B67-43001-291 CLAMP BUSHING C6-1

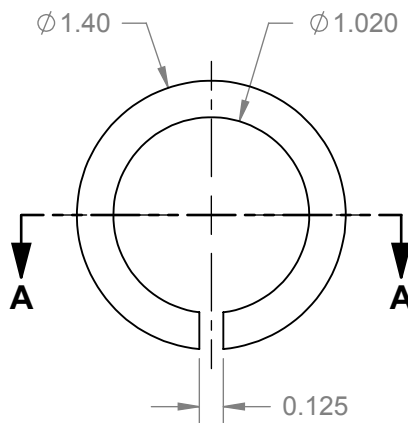
D	MATERIAL WAS 6061-T6R REASON: IMPROVEMENT, CHANGE HEIGHT ON PART WAS 0.480 (PAR15-437)	SAD	16.10.19
C	REDRAWN PREMIER AVIATION DRAWING IAW DART QSI 018 AND QSI 043. FOR PREVIOUS REVISIONS, REFER TO PAGE 38 OF PREMIER AVIATION DRAWING No. B67-43001. REASON: SEE PAR#09-011.	MB	09.02.26
REV.	DESCRIPTION	BY	DATE
DESIGN	RW	DART AEROSPACE LTD HAWKESBURY, ONTARIO, CANADA	
DRAWN	SAD		
CHECKED	MB	DRAWING NO.	REV. D2
MFG. APPR.	JLM	B67-43001-291	SHEET 1 OF 1
APPROVED		TITLE	SCALE
DE APPR.		CLAMP BUSHING	NTS
DATE	16.10.19	COPYRIGHT © 1995 BY DART AEROSPACE LTD <small>THIS DOCUMENT IS PRIVATE AND CONFIDENTIAL AND IS SUPPLIED ON THE EXPRESS CONDITION THAT IT IS NOT TO BE USED FOR ANY PURPOSE OR COPIED OR COMMUNICATED TO ANY OTHER PERSON WITHOUT WRITTEN PERMISSION FROM DART AEROSPACE LTD.</small>
